Lot 141 - Duncan's Creek

Wilson - LH ELEVATION 'D'

Redlines Completed 1-Jul - DP

WILSON
Cover Sheet 'D'

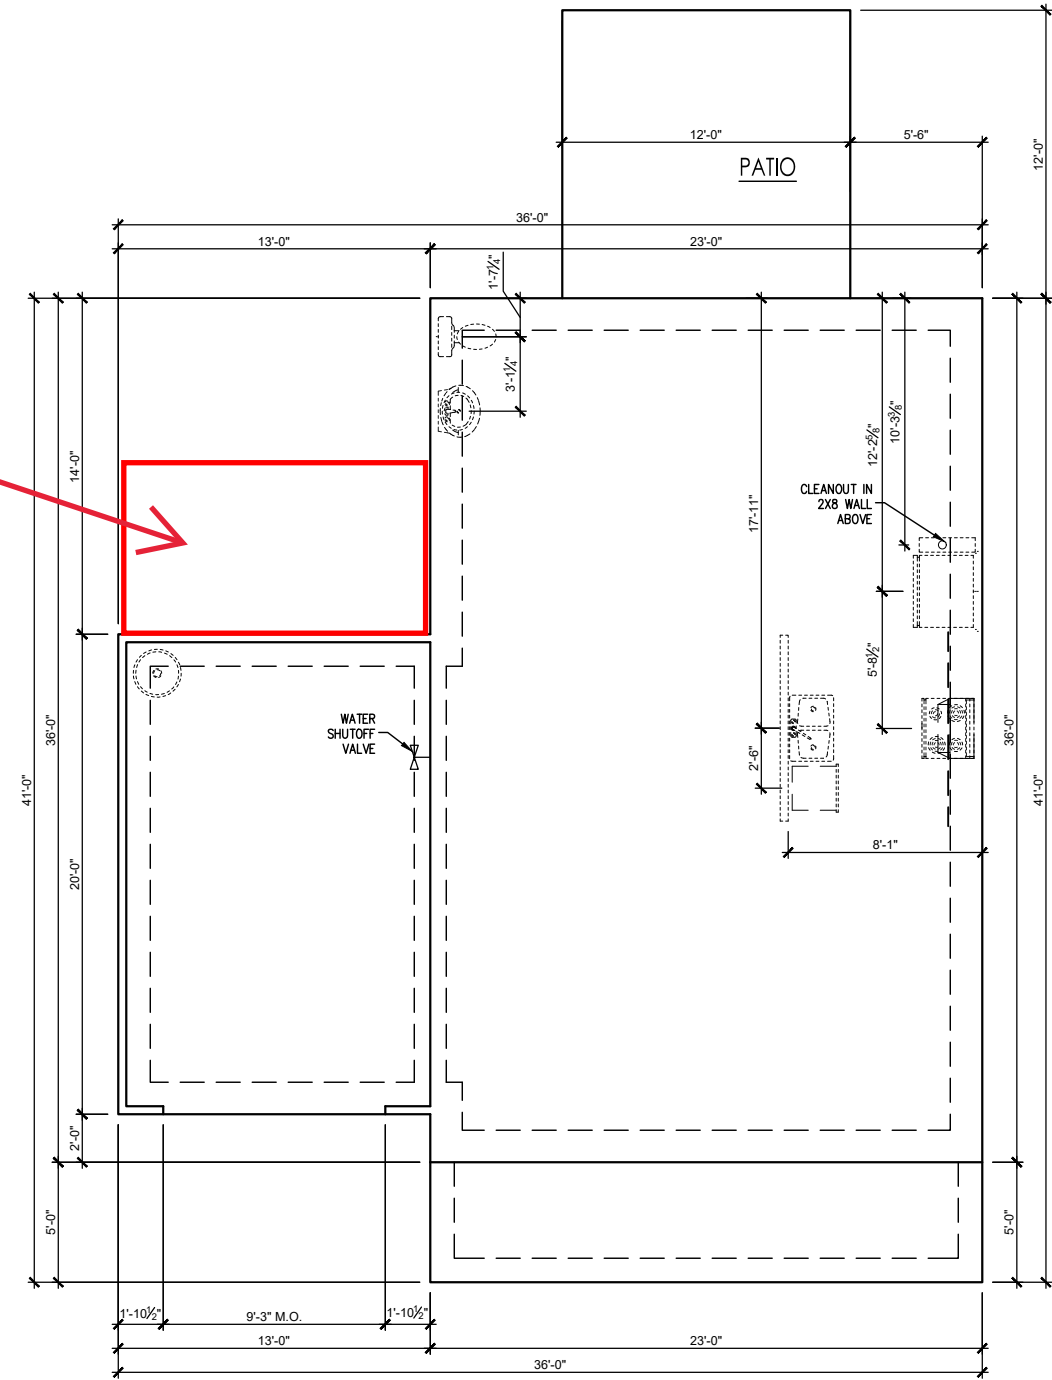
Unheated Additions:
Patio at Garage - 13'x8' = 104
Parking Pad - Field Measured = TBD

SLAB FOUNDATION ELEVATION 'D'
 SCALE: 1/4" = 1'-0" ON 22x34, 1/8" = 1'-0" ON 11x17

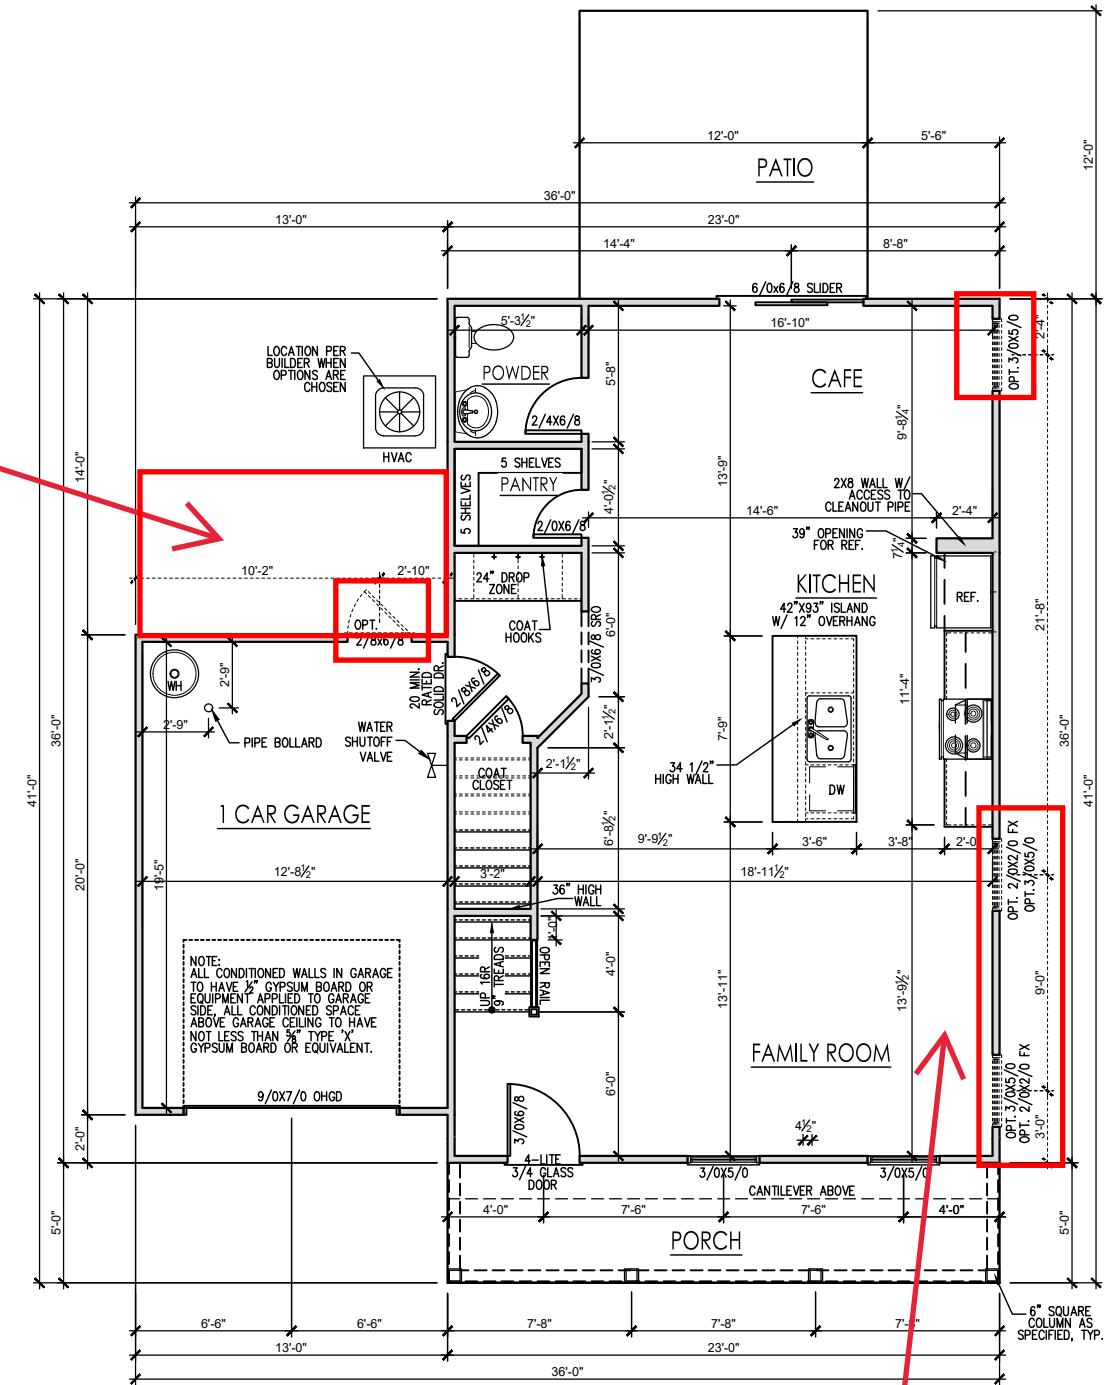
Add Patio off rear of garage. 13' x 8'

FIRST FLOOR - ELEVATION 'D'
SCALE: 1/4" = 1'-0" ON 22x34, 1/8" = 1'-0" ON 11x17

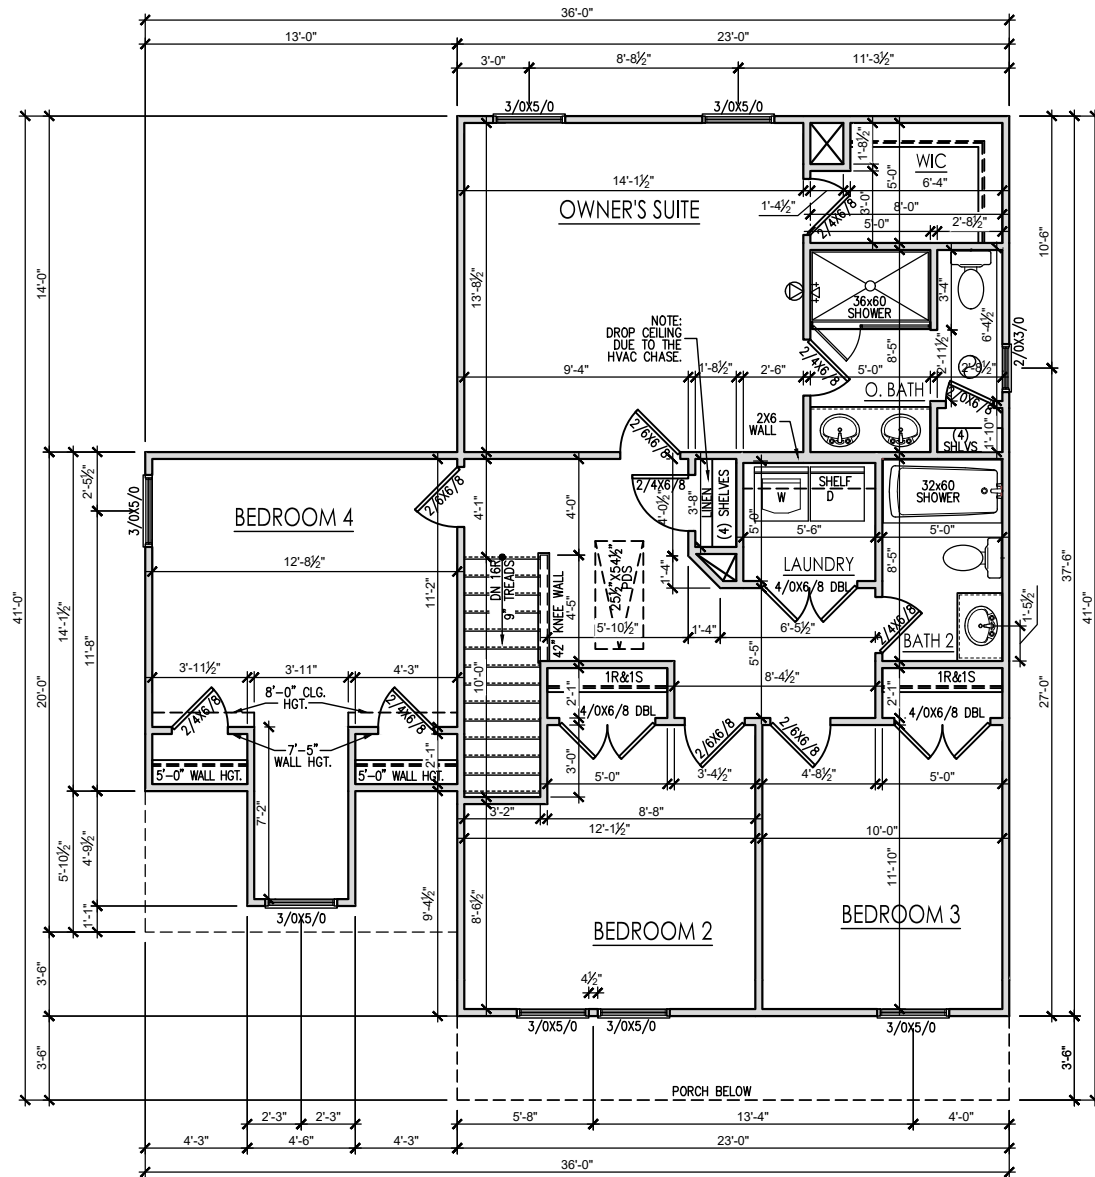
Add 13' x 8' Patio

Add (2) 3/0 x 5/0 windows in Family
